# WOLF CREEK

GC 02-0011

Subject: Docket No. 50-482: Supplemental Information for the Relocation of Technical Specification Cycle Specific Parameters to the Core Operating Limits Report

**ATTACHMENT I**  
**TECHNICAL SPECIFICATION CORRECTION**

Table 3.3.1-1 (page 5 of 6)  
Reactor Trip System Instrumentation

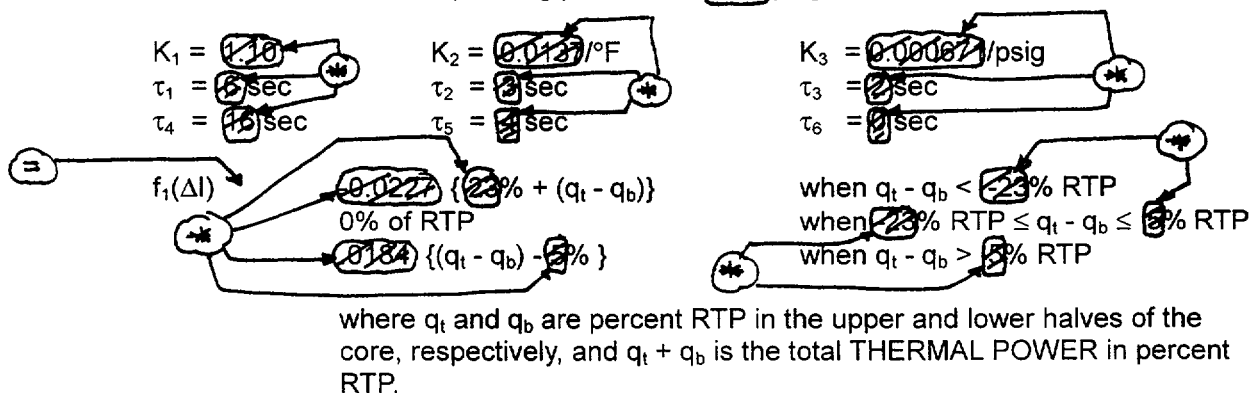
On February 28, 2002, Wolf Creek Nuclear Operating Corporation (WCNOC) personnel identified a potential error with the proposed change to the  $f_1(\Delta I)$  equation in Technical Specification Table 3.3.1-1. The current  $f_1(\Delta I)$  equation is specified, in part, as follows:

$$f_1(\Delta I) = -0.0227 \{ 23\% + (q_t - q_b) \} \quad \text{when } q_t - q_b < -23\% \text{ RTP}$$

Reference 1 proposed to change the "+" sign to a "-" sign. This change was based on a proposed method of defining the  $f_1(\Delta I)$  breakpoints and slopes in the COLR. Upon further review it was identified that the change proposed to the  $f_1(\Delta I)$  equation would result in an inconsistent application of the breakpoints and slopes.

The Attachment provides a revised markup of Technical Specification page 3.3-19. The correction to the proposed changes to the Technical Specifications do not impact the conclusions of the No Significant Hazards Consideration Determination provided in Reference 1.
